FINAL ENVIRONMENTAL IMPACT STATEMENT

STAR WAREHOUSE EXPANSION

20 Industry Drive
Town of Cornwall, Orange County, New York

March 7, 2024

Figure 3.7-2 Photo from Location 8 – Hill at South Field Cell tower on Star Warehouse property is visible above tree line in center of photo, facing southwest.

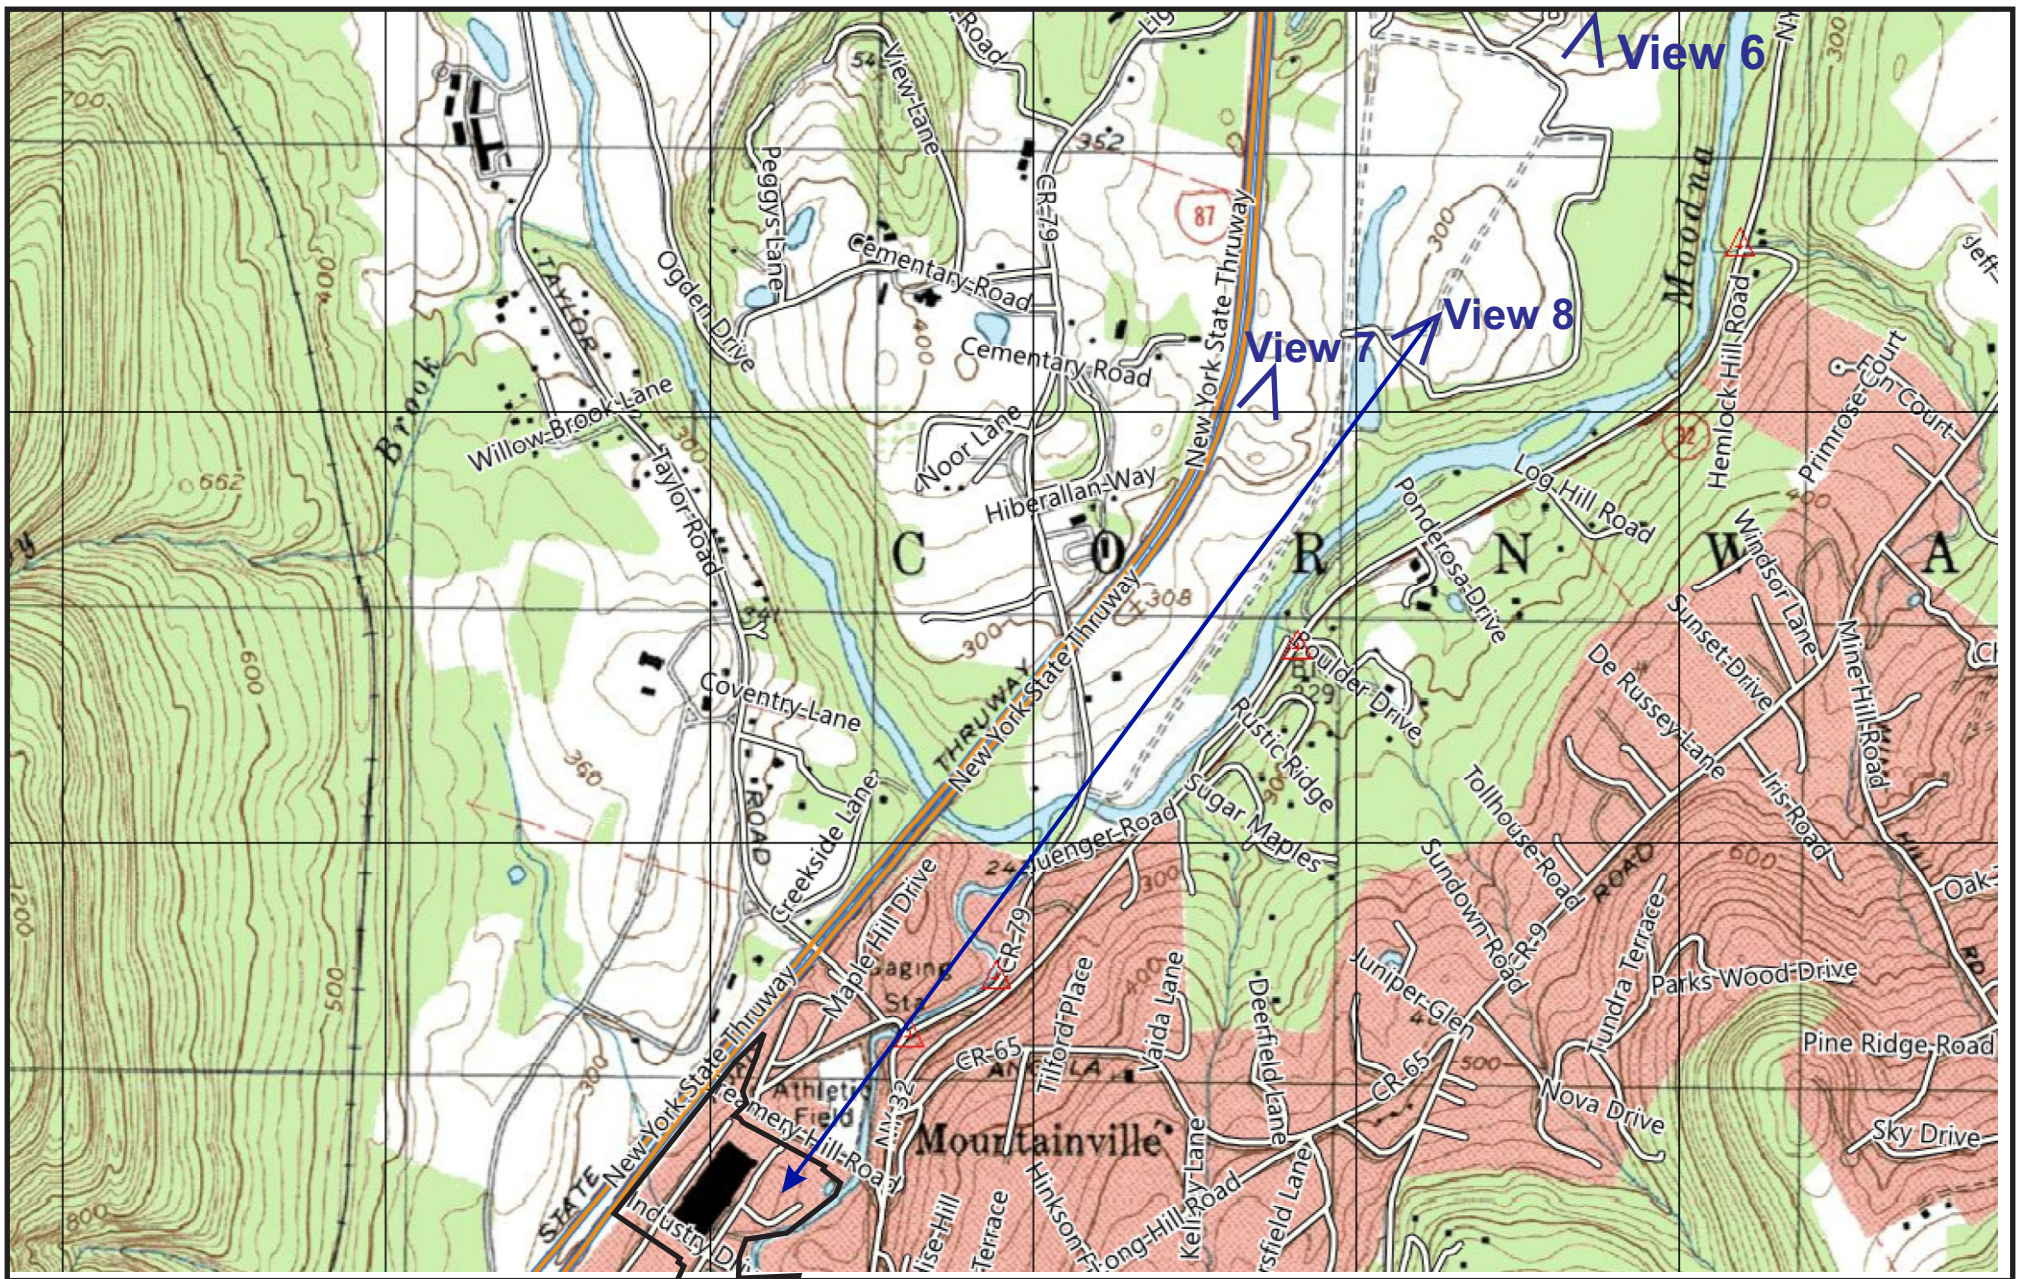
Additional photographs from Storm King Art Center towards the project site were taken on April 21, 2023. At the time of the photos, leaves were newly apparent on trees, and the trees were not bare. As requested by Storm King Art Center photos were taken from a hilltop in the southern portion of the Art Center grounds, above the south ponds. The location of this vantage point is designated as Location 8 and is shown in Figure 3.7-1. Locations 6 and 7 in the DEIS were from two vantage points from Storm King Arts Center. Location 8 is approximately 1.5 miles from the subject property.

From Location 8, the existing cell tower on the site is visible on the horizon in the southern direction, as shown in the photo in Figure 3.7-2. The existing water tank was not visible from this vantage point and the proposed warehouse addition will not be visible, as further discussed below. Additional photos were taken from Location 6 (Museum Hill) and Location 7 (hill above the Maya Lin Wave Field) in April, 2023. The cell tower on-site was visible from Location 6, Museum Hill (Figure 3.7-3), but was not visible from Location 7 (Figure 3.7-4), the hill above the Wave Field. Based upon observations and photographs taken on two occasions at Storm King Art Center, the project will not have an adverse visual impact upon the Art Center.

Figure 3.8-1: Remedial Investigation Sample Location Map
Star Warehouse Property
Town of Cornwall, Orange County, New York
Source: TRC Engineers, Inc.

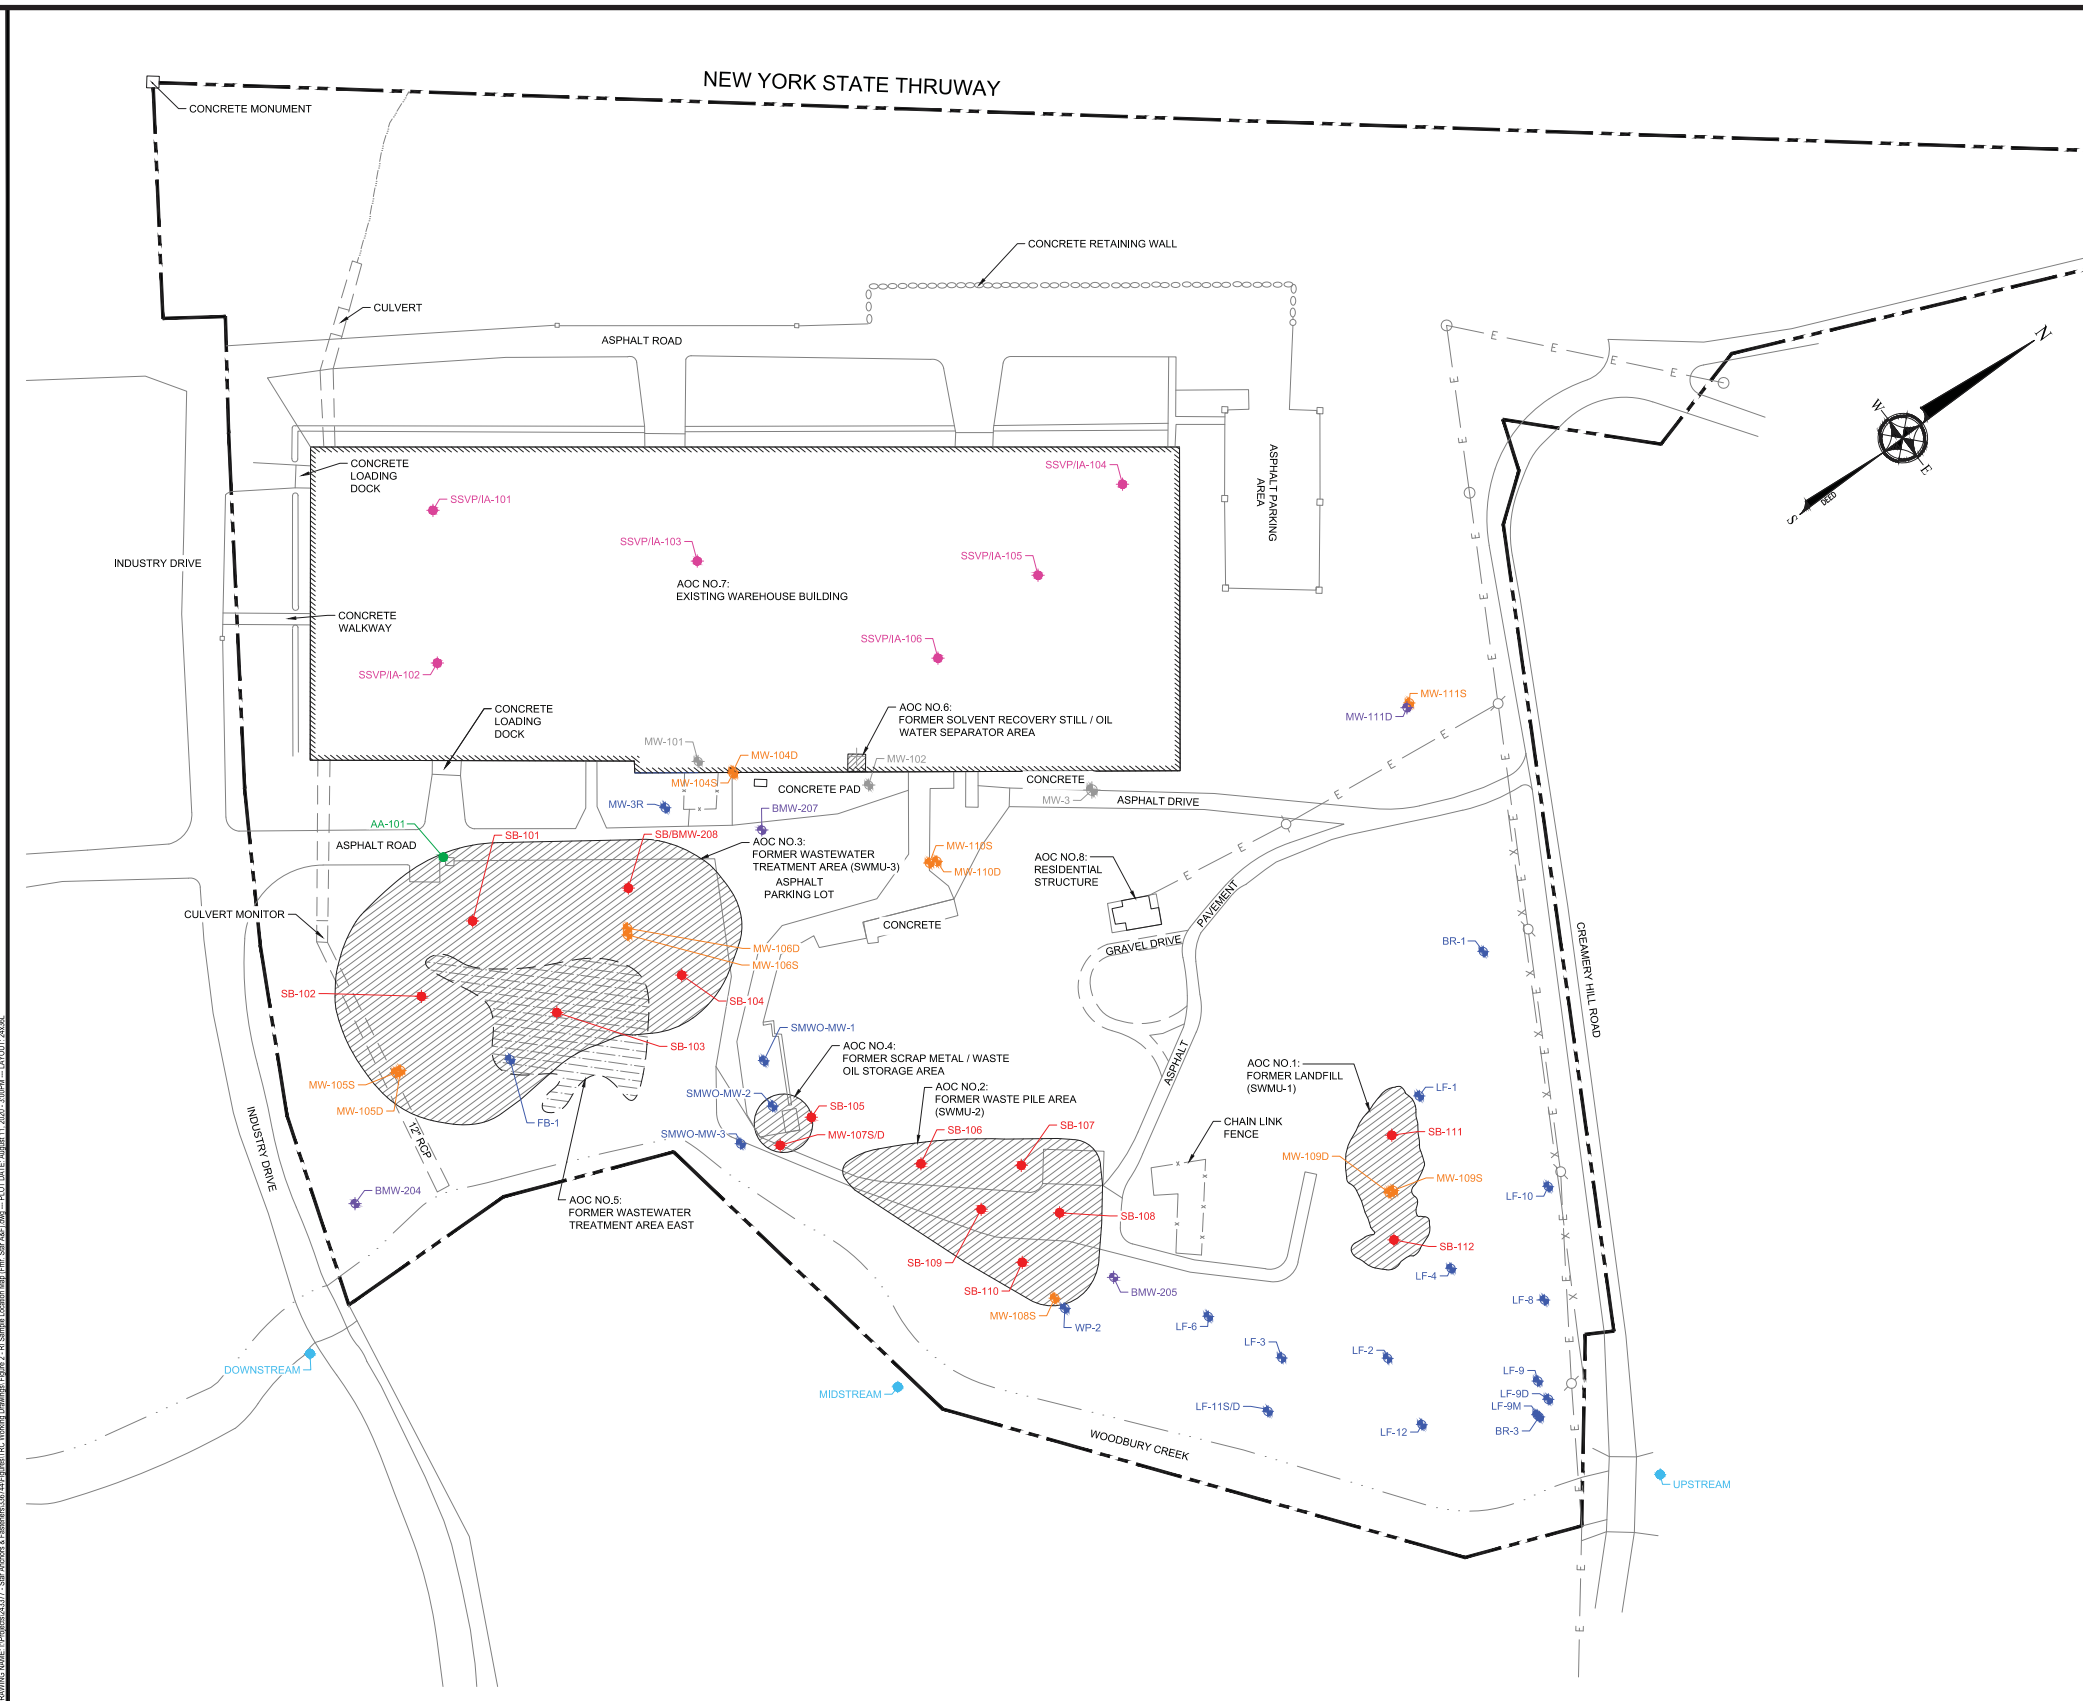
Comment 3.8-12 (Public Hearing January 3, 2023, Mr. Joe DeSalvo): There ought to be some kind of really in-depth environmental study penetrating that ground to see at least, so you can at least map, get some kind of map to say hey, you know what, this is not going to be anywhere near that, we did a survey and we found out.... There ought to be a good site survey with penetration that at least show where this Superfund classified material is, where it is and the density and the specific locations so at least we have some kind of idea. Because otherwise you just can't go out there with a gas detector, take samples and say yeah, we think there's something here that might have been, let me take that over there.

Response 3.8-12: *As described above, several in-depth environmental investigations and clean-up have occurred over the period 1994 through 2000. These studies and results are provided in the Remedial Investigation Report prepared by TRC Engineers, Inc., as provided in Appendix E of the DEIS. A Remedial Investigation Sample Location map was included in the DEIS and is provided as Figure 3.8-1, following this section. The map shows multiple sampling locations for: soil, surface water, groundwater, indoor*

air and outdoor air. The map shows the eight (8) areas of concern, as identified by TRC Engineers, Inc.
